**DANE COUNTY DEPT. OF
PUBLIC WORKS, HIGHWAY &
TRANSPORTATION**

ADDENDUM

RFB NO. 317049 - ADDENDUM NO. 2

BIOGAS FACILITY CONSTRUCTION

CONDENSATE PUMP STATION (CS-3)
DETAIL 1
 SCALE: NOT TO SCALE C508

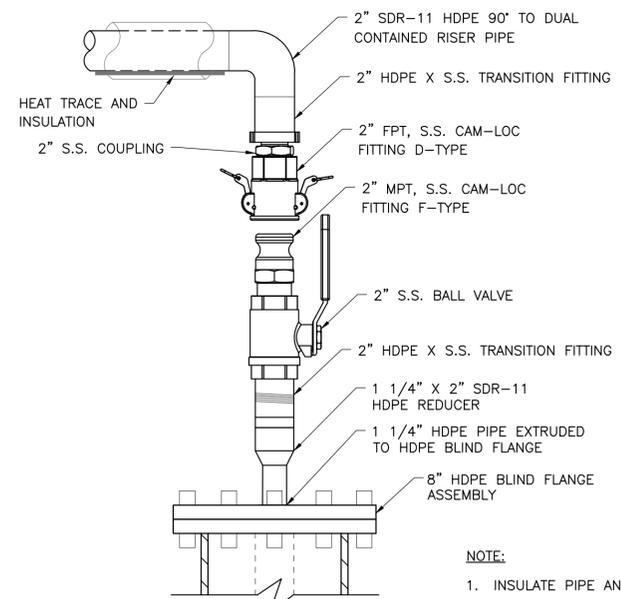
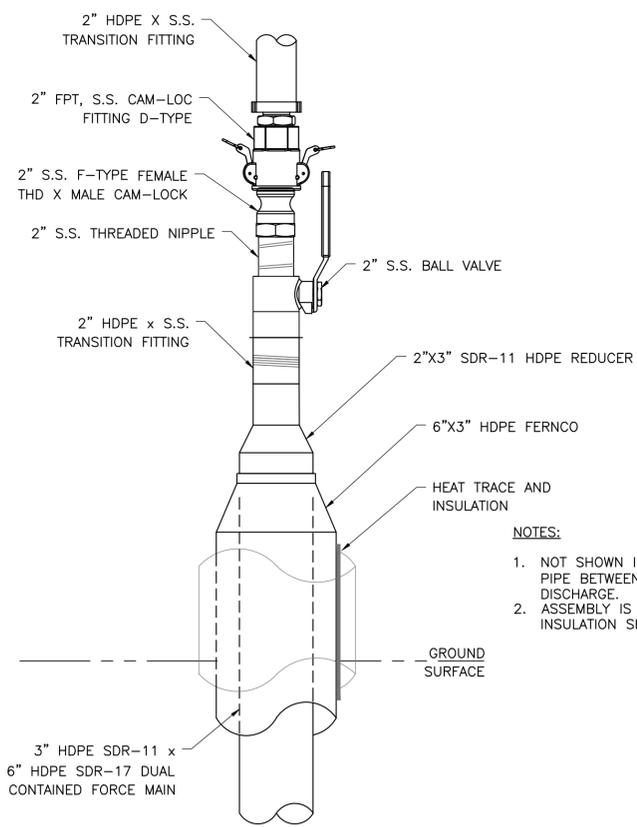
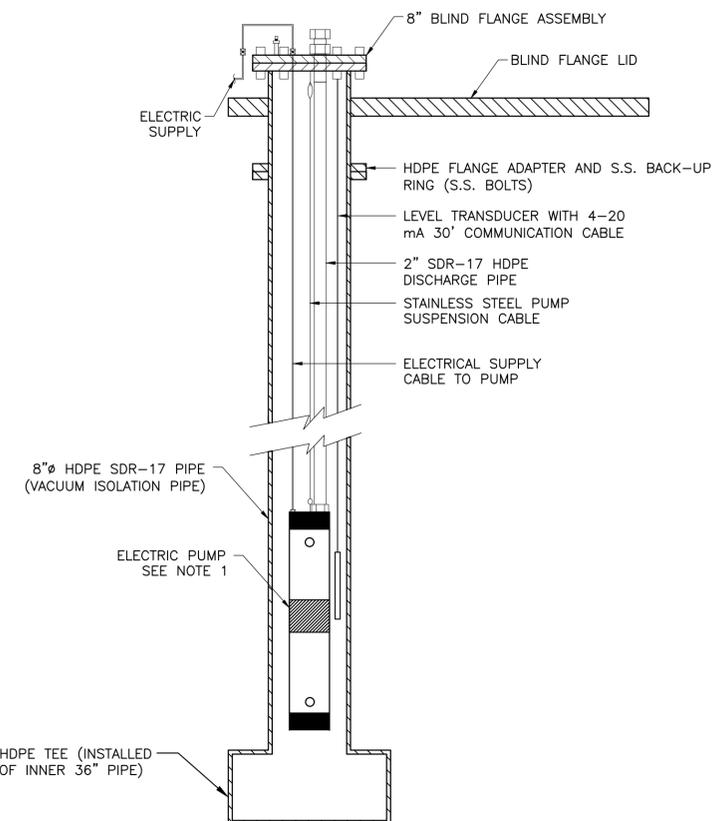
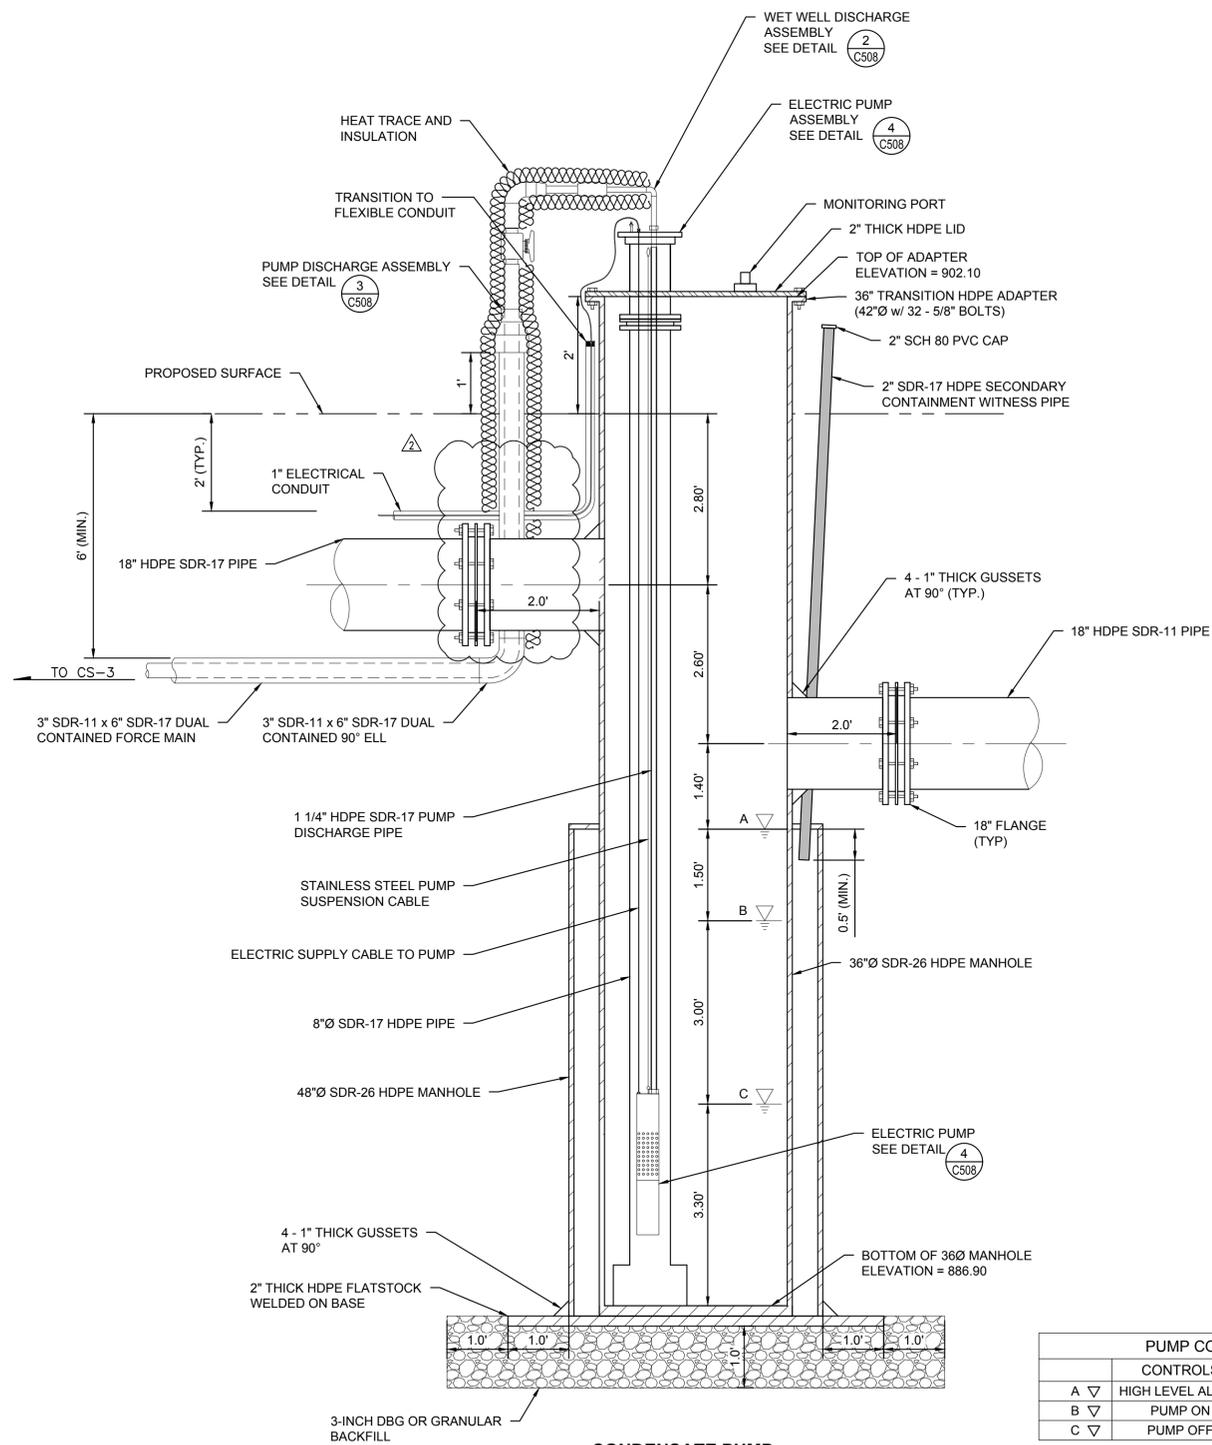
- 8. Sheet C508**
Updated to show heat trace and insulation below grade on Condensate Pump Station CS-3

C509

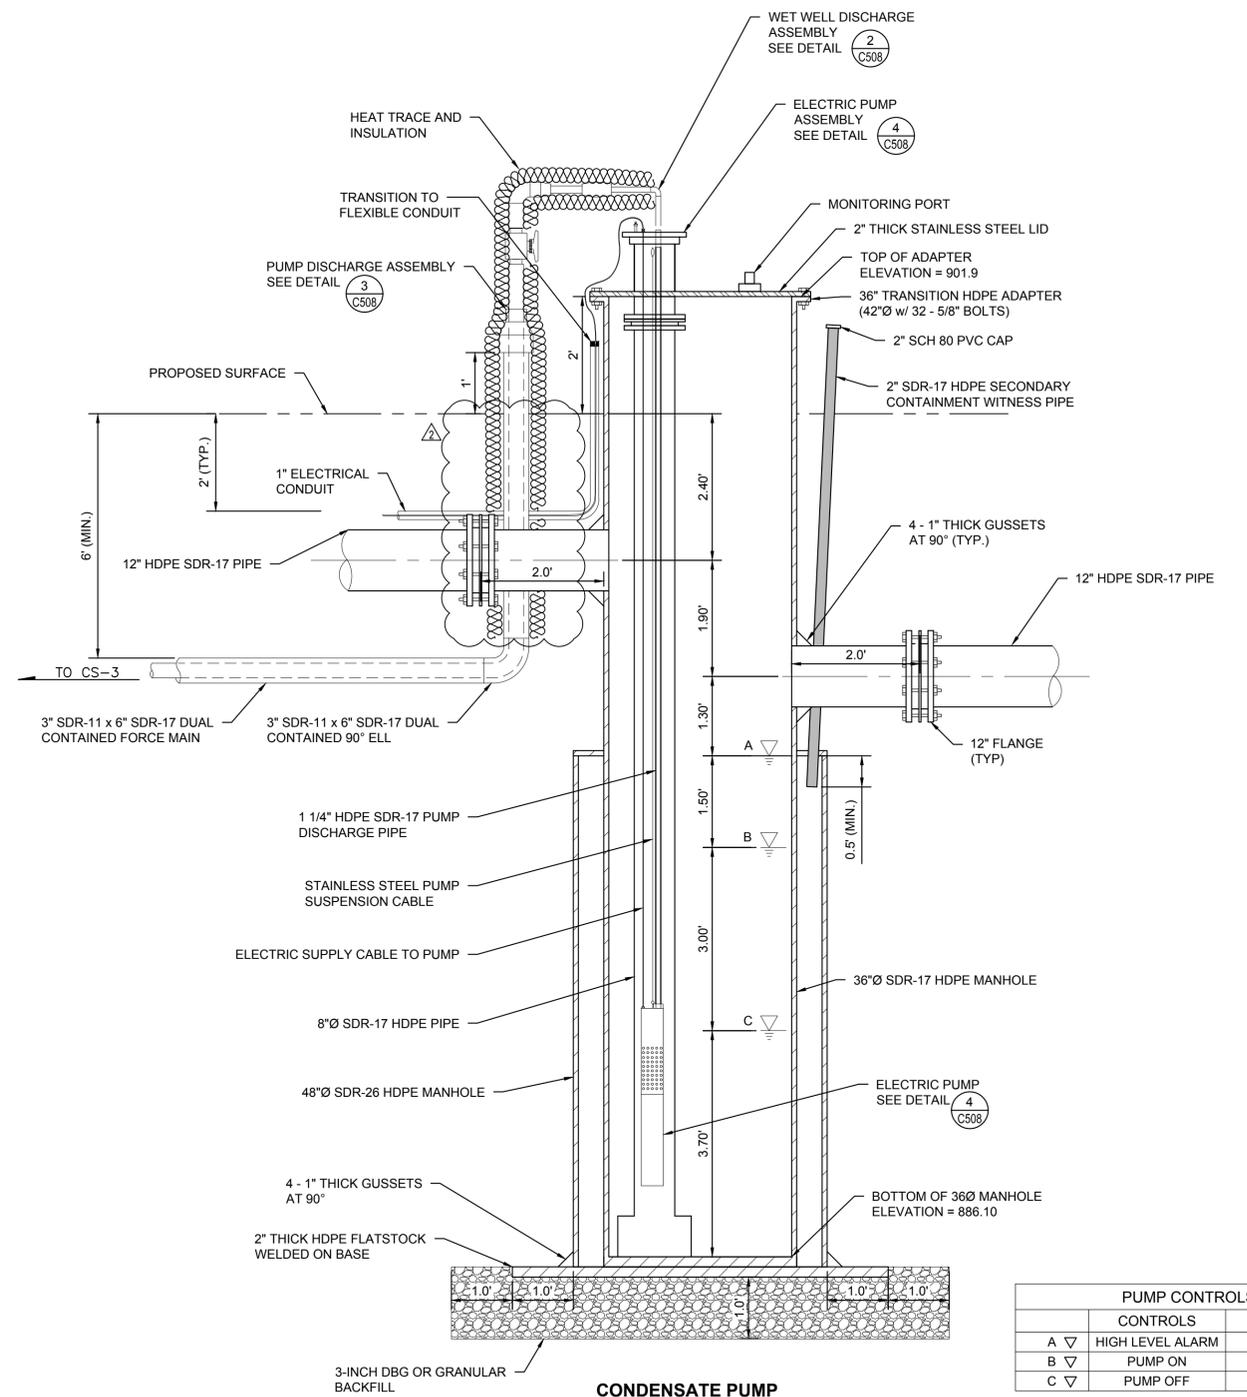
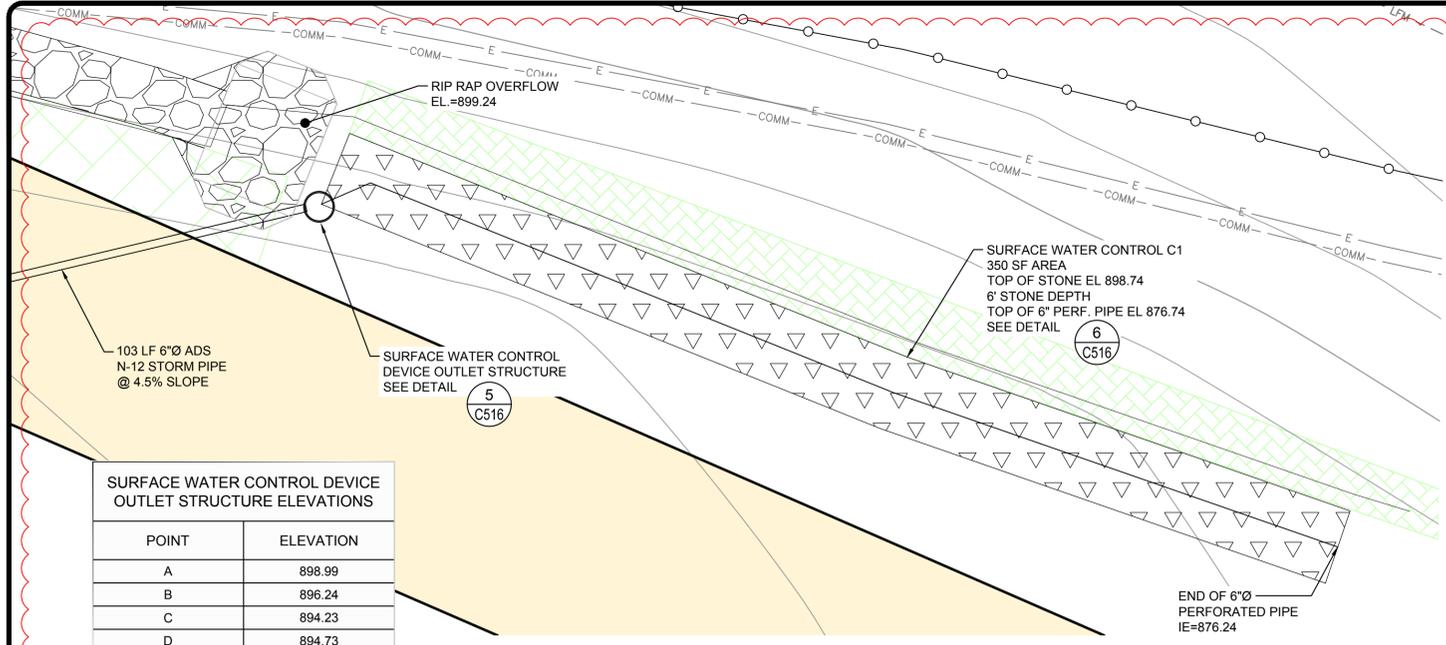
9. Sheet C509

Updated to show heat trace and insulation below grade on Condensate Pump Stations CS-1 and CS-2

SHEET NO.
C516
PROJECT NO.
170651

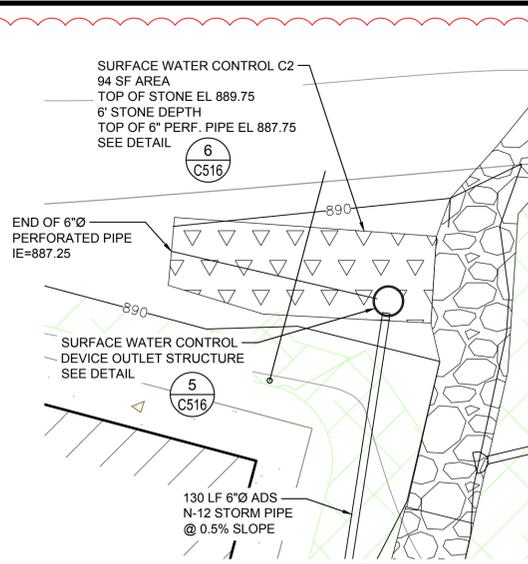
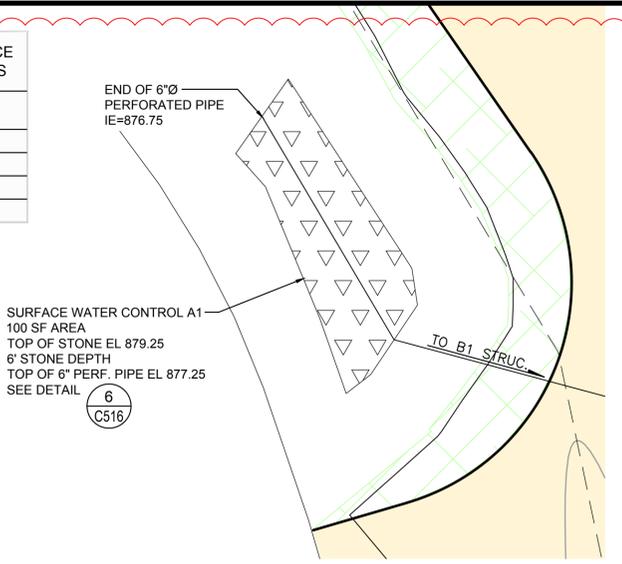
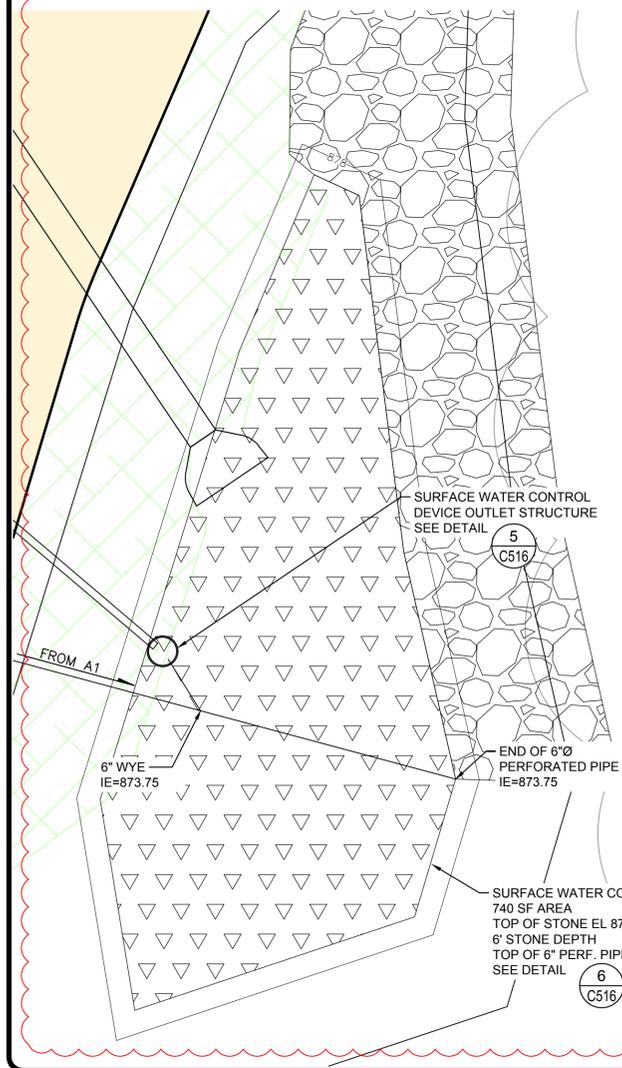
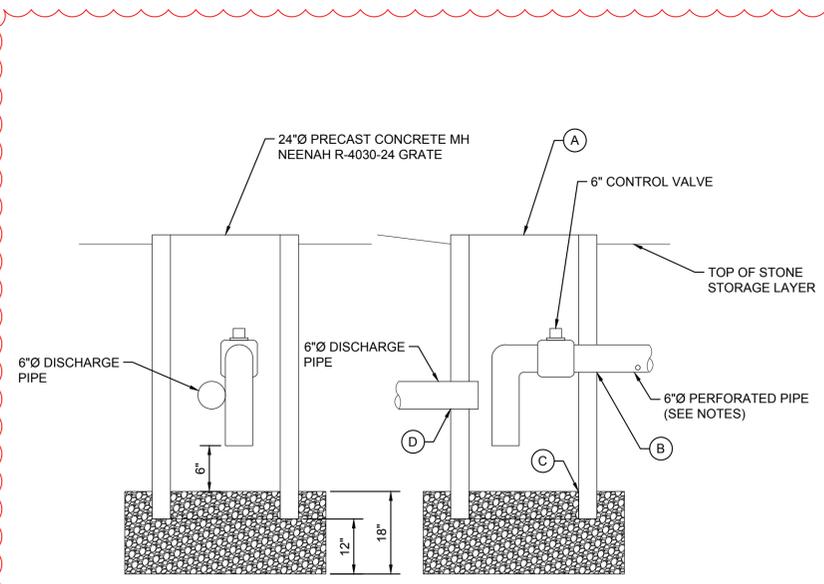
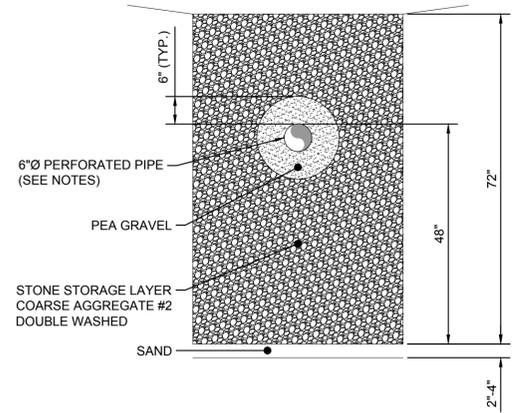
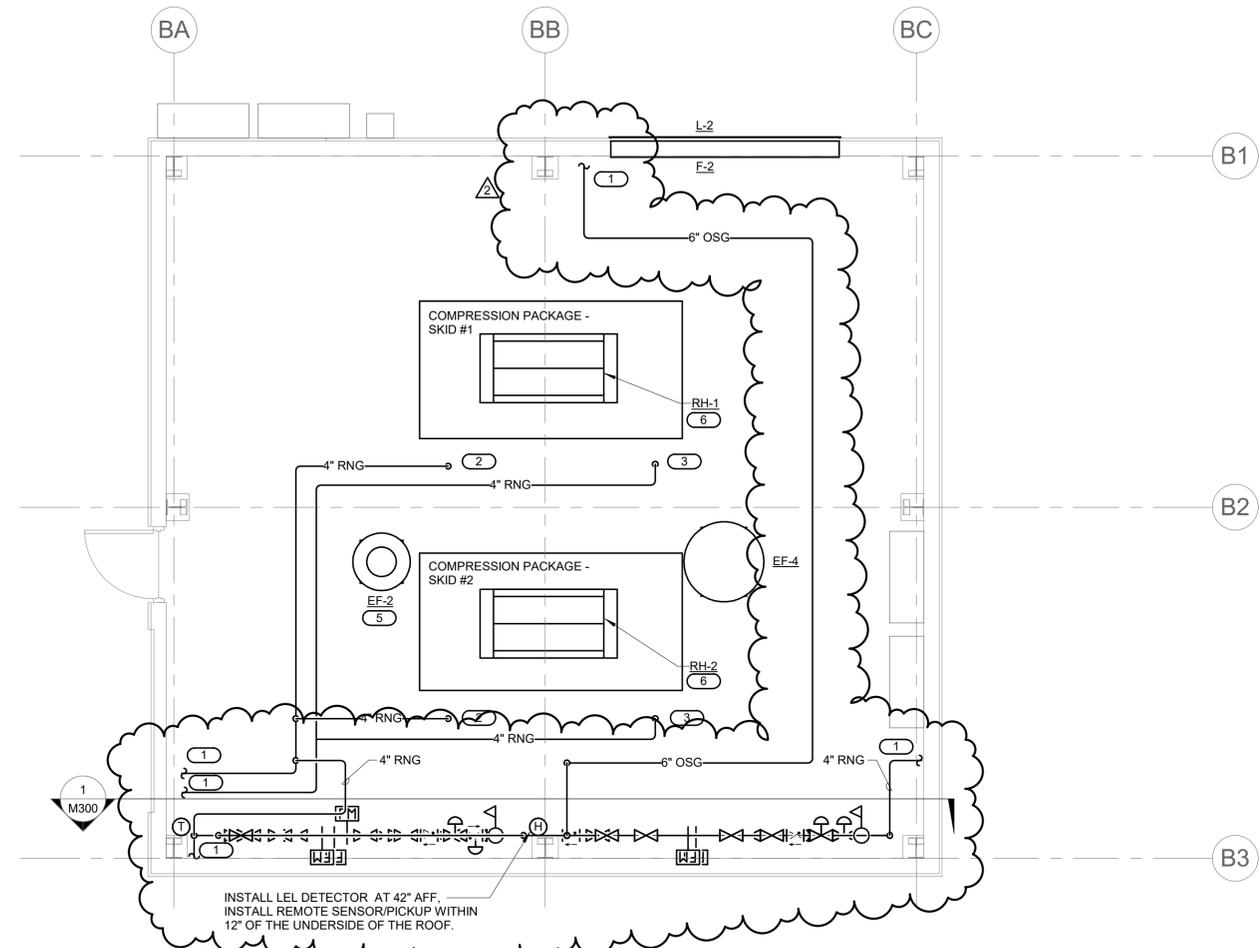
10. Sheet C516

Updated surface water control device details to meet requirements for oil and grease collection.

SHEET NO.
M101
 PROJECT NO.
 170651

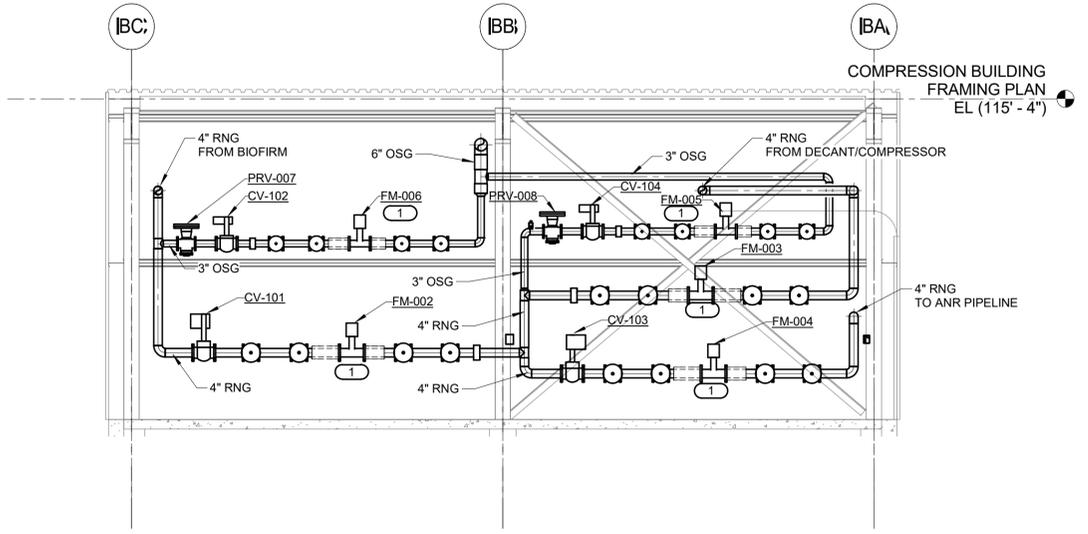
11. Sheet M101

Updated to include off spec gas piping and flow meters 5 and 6.

Q14: Can you submit an RFI for the Compressor Building. The plan view on M101 doesn't match the P&ID. The plan is missing OSG piping, flow meters 5,6 & 7? On the section view on M300 the lines from flow meters 1, 2 & 3 are labeled CR, but there isn't a CR line type?

A14: *Sheet M101 has been revised to include the missing off spec gas piping and flow meters 5 and 6. Flow meter 7 can be found on Sheet C122 (6" flow meter adjacent to the heat exchanger).*
